TITLE:  
ITEM NO:  
DESC.: PLAN, ELEVATIONS, DETAIL  
DESC.: CAFE PANTRY 3392

By: PD Scale: As Noted Job No. Dwg. No.  
Status: IN SUBMITTAL REVIEW Date: 2019-07-08 **02-01**

TITLE:	SECTIONS	Job No.	Dwg. No.
ITEM NO.:	CAFE PANTRY 3392	Scale: As Noted	02-04
DESC.:		Status: IN SUBMITTAL REVIEW	Date: 2019-07-08

ISOMETRIC VIEW OF TABLE LEG  
SCALE: NTS  
ArchT Ref.:

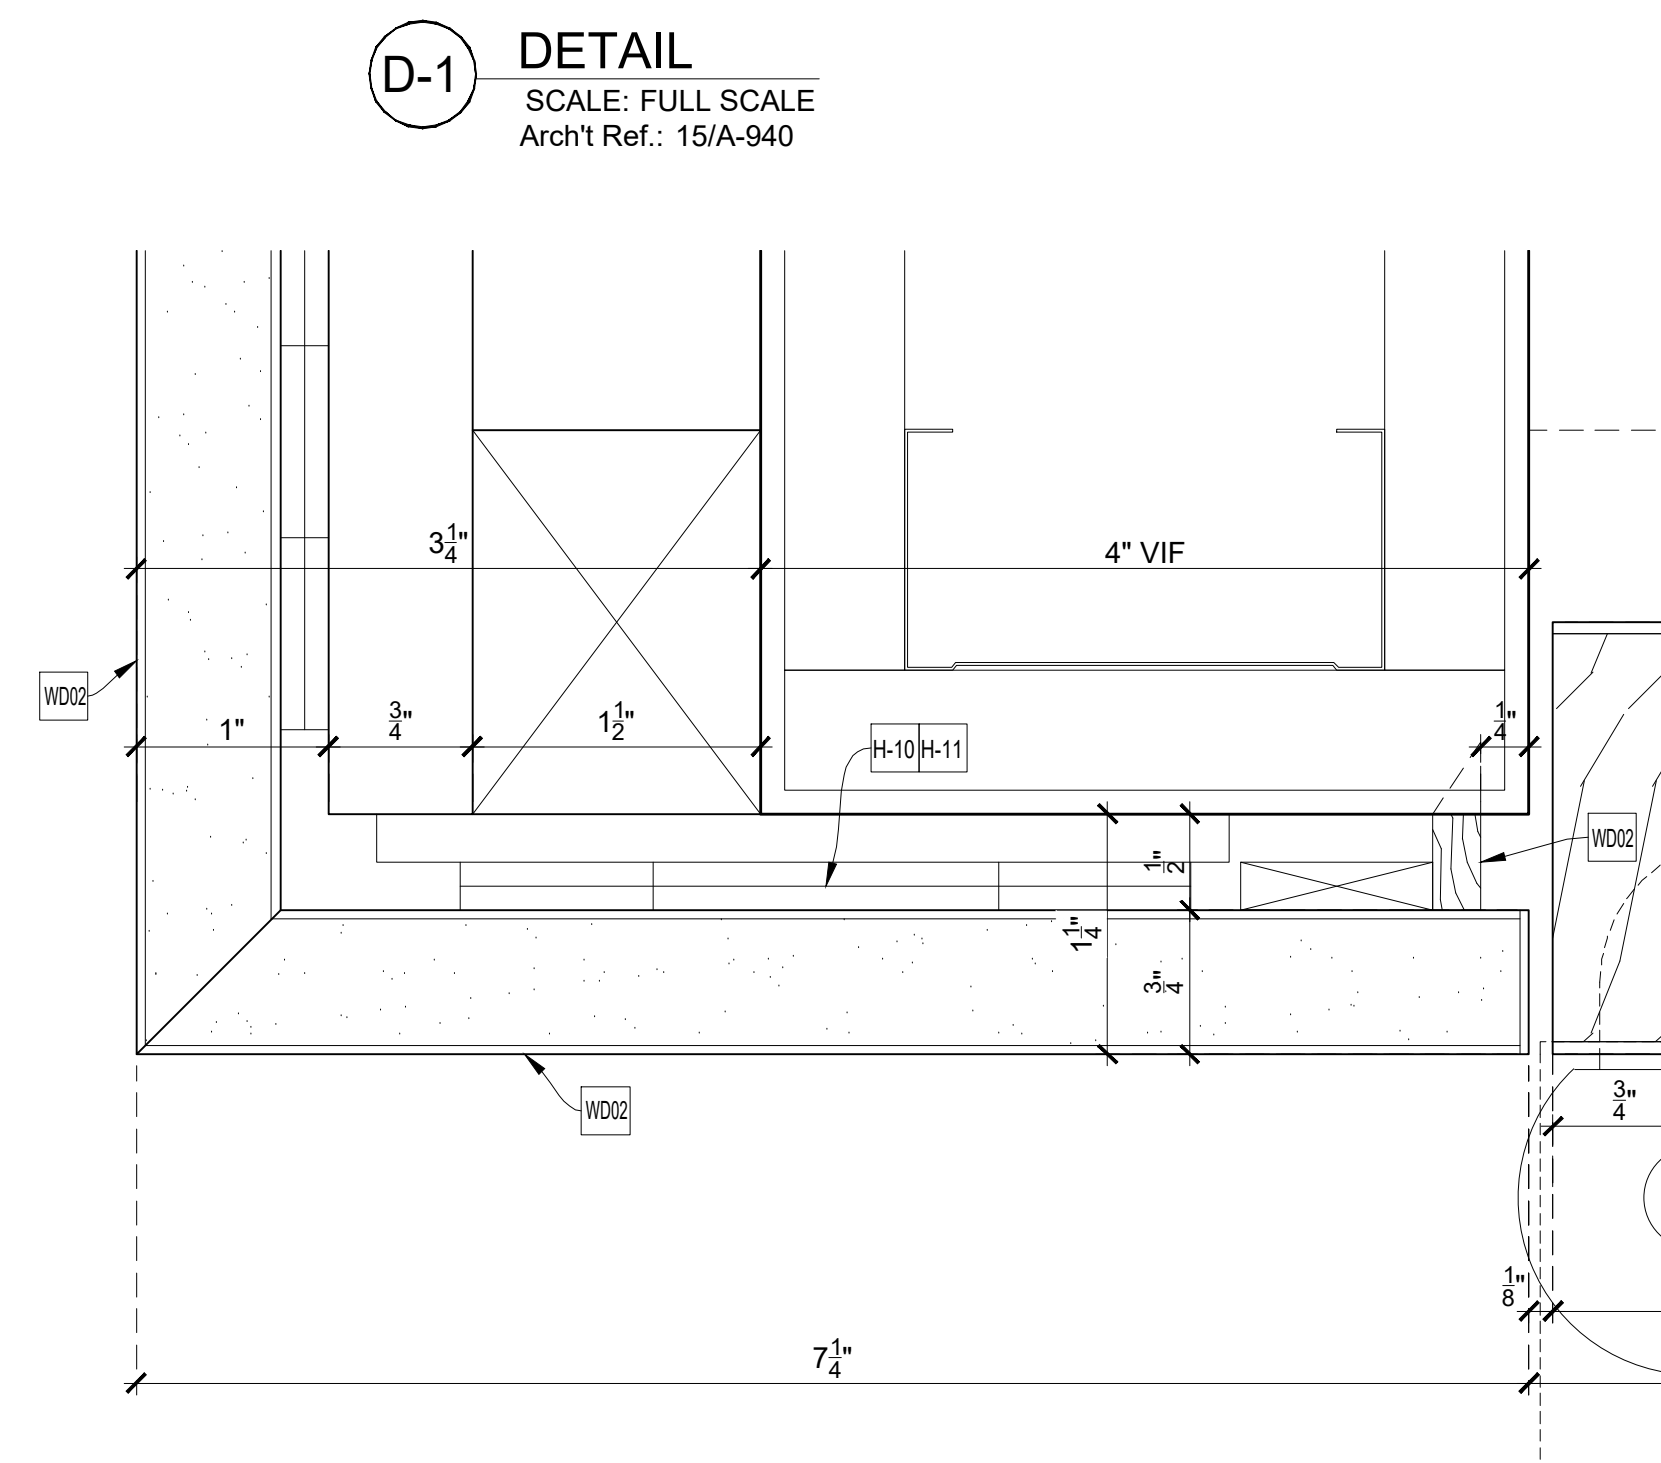
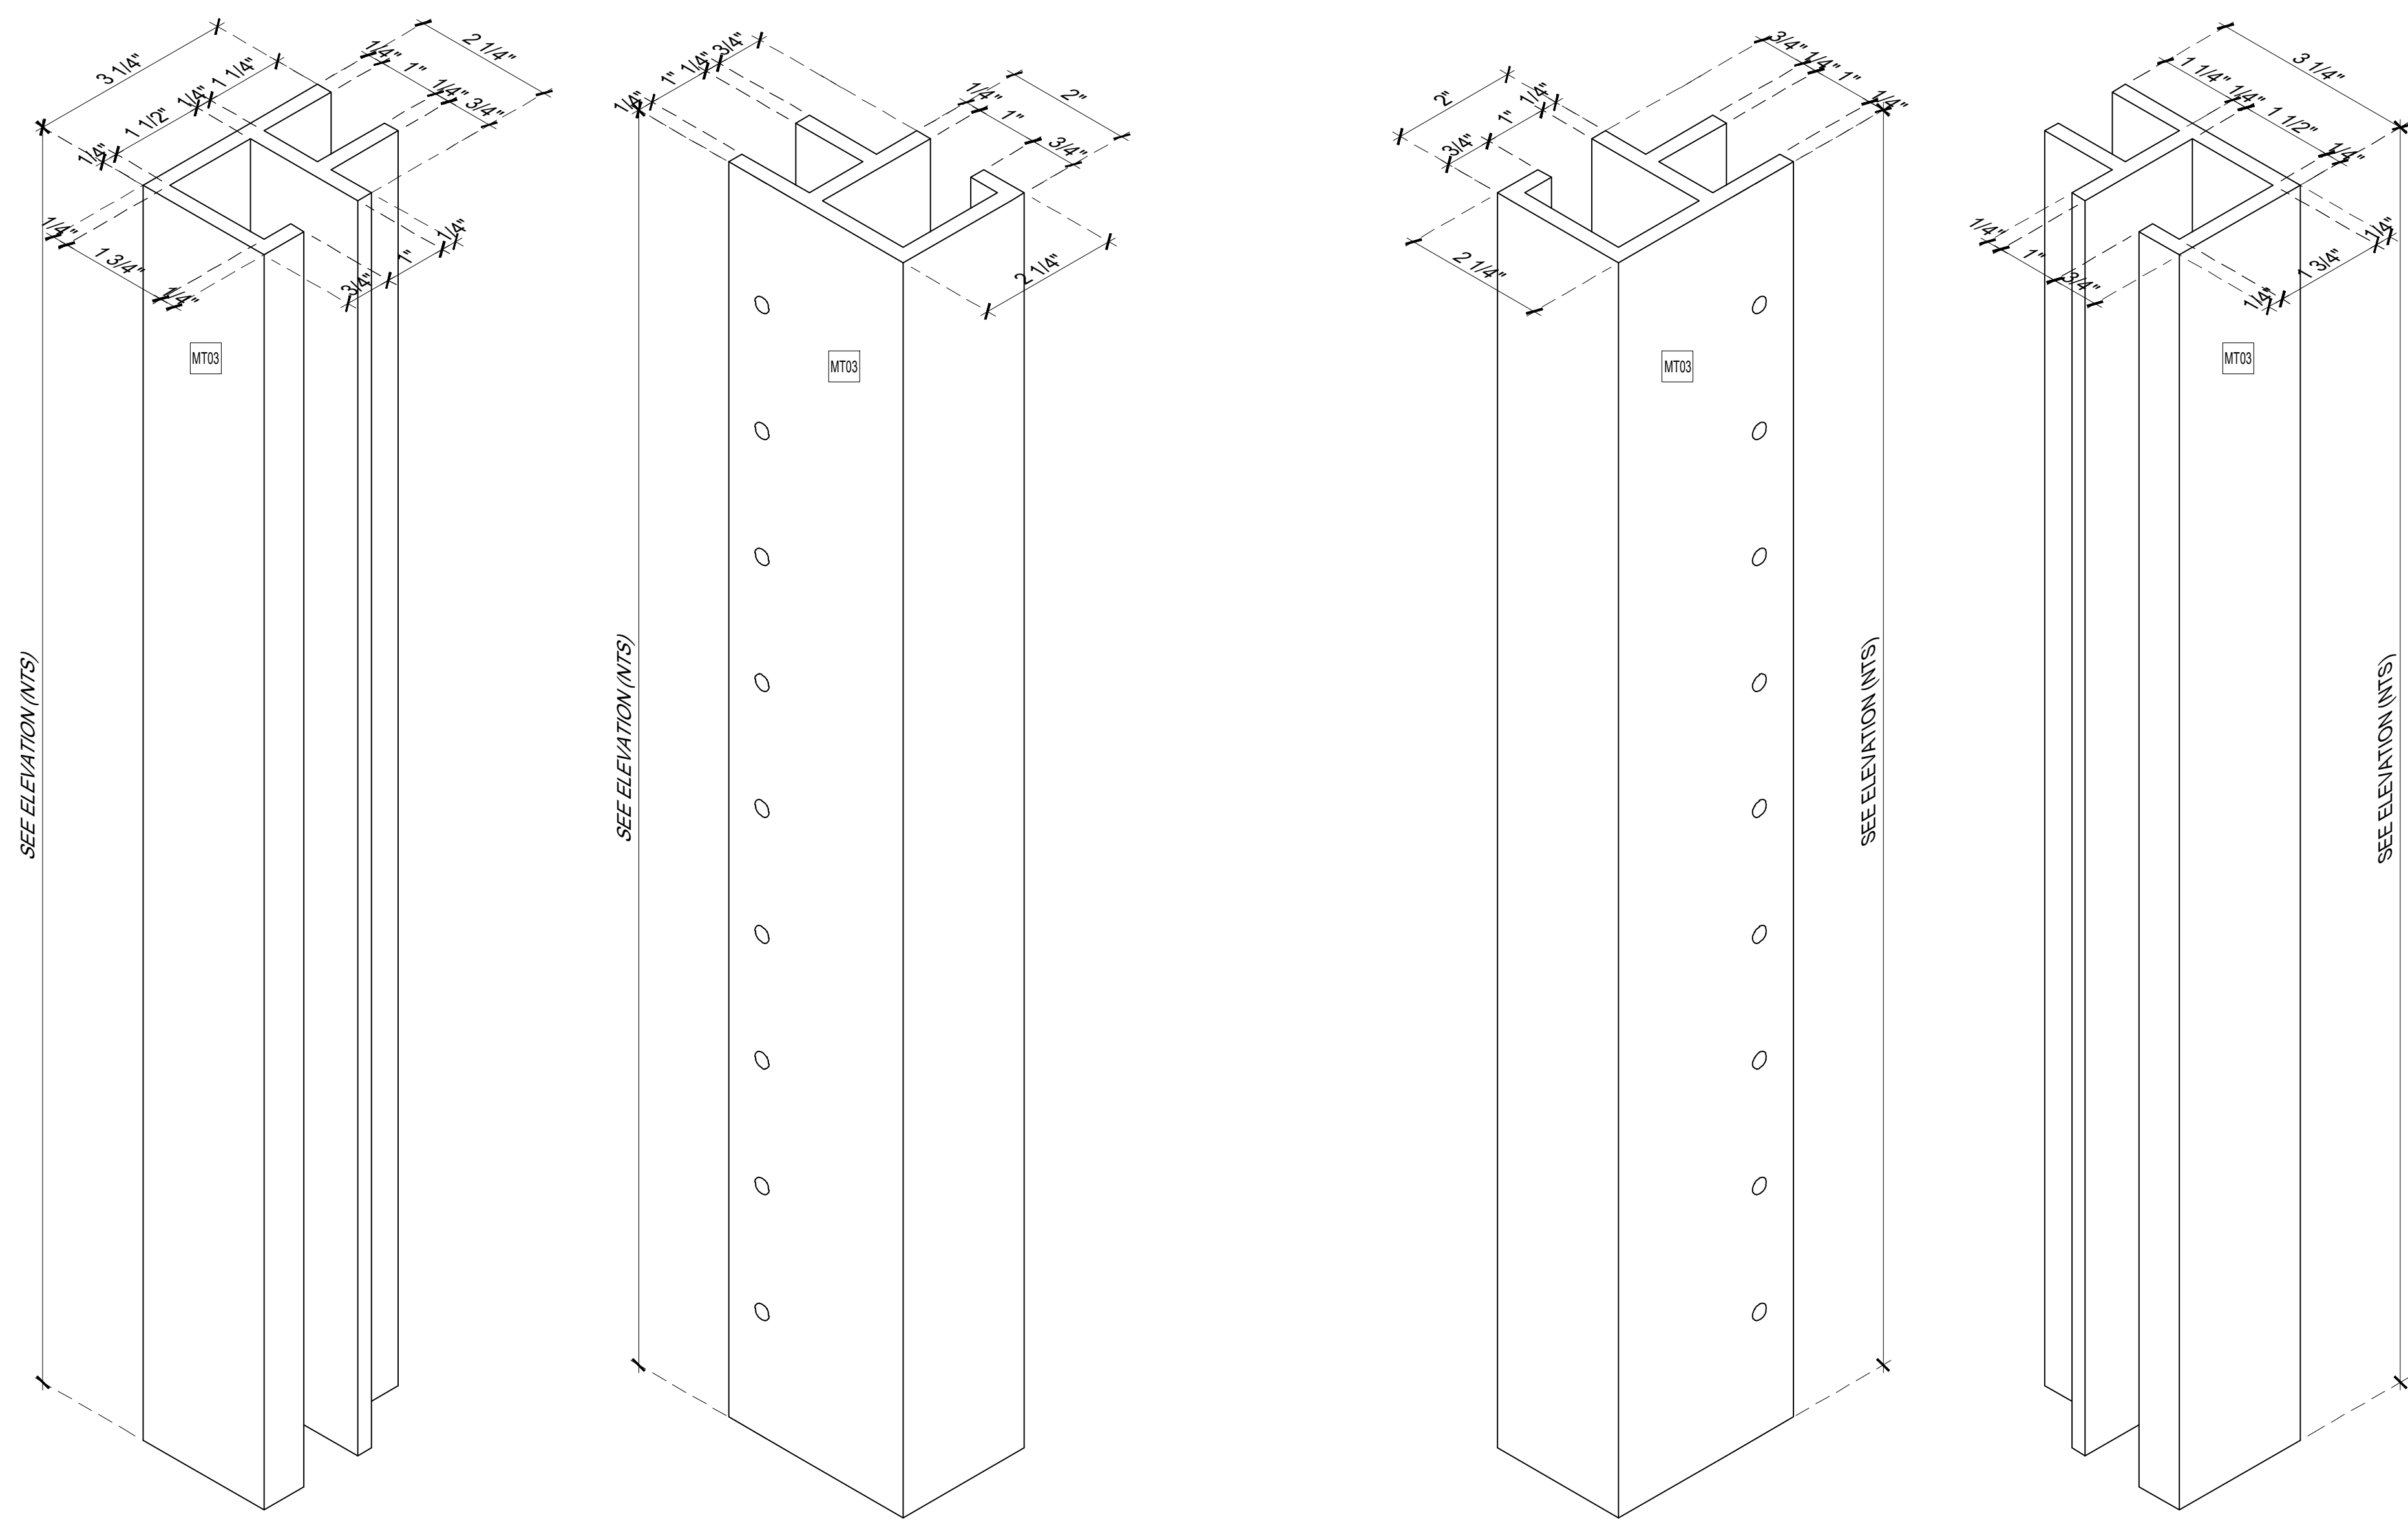
ARCHITECT NOTE:  
PLEASE VERIFY  
FINISHES

ARCHITECT NOTE:  
TO THIN LEG MBR RECOMMENDS  
METAL POWDER LEGS.  
PLEASE VERIFY.
